: BRACKET ASSEMBLY

: D3121041

NCR: 39183 WORK ORDER NON-CONFORMANCE (NCR)								
DATE	CTED	Description of NC		Corrective Action Section B		Verification	Approvai	Approval
DATE	STEP	Section A	Initial Chief Eng	Action Description Chief Eng	Sign & Date	Section C	Chief Eng	QC Inspector
∆8.05.7°o	3	Holes are 0.030" down 12. 0.300 Dim is 0.270".	08.05.30 pu 051042	Machine hole to add 0.030" TO TOP OF HOLE	08/04/11	88-06-(1	prian	104-0611
		•

Subject: RE: NCR D3121-11

D3121-11 BRACKET

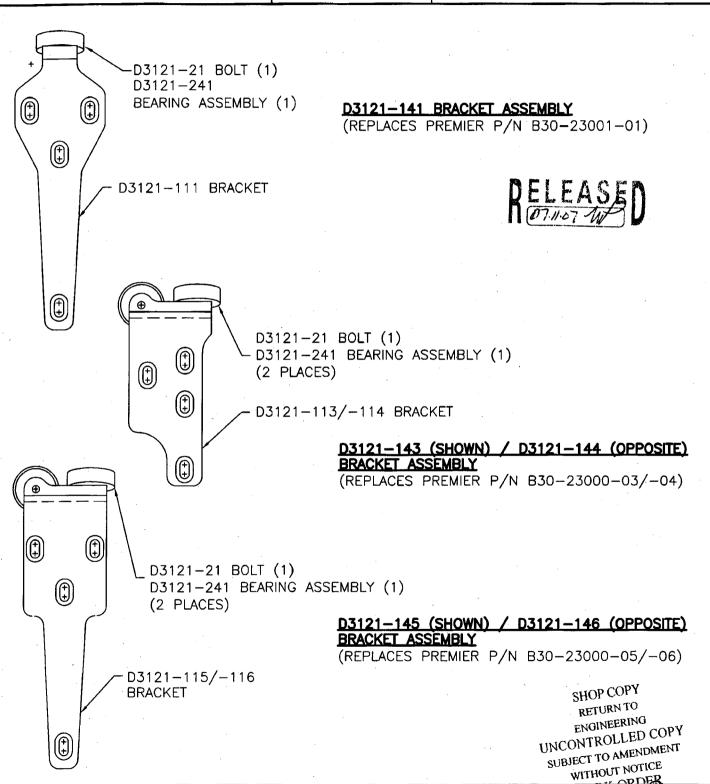
Can they elongate the slots 0.030" upwards to regain the original flexibility of the part?

Qty(1) D3121-11 Bracket. All the holes are shifted down 0.030" from nominal. The 0.300" dim is 0.270". Is this acceptable?

I would say the part is OK considering it's slotted and can be adjusted, but I'm not sure how much play is actually needed for the slots.

That's acceptable to me.
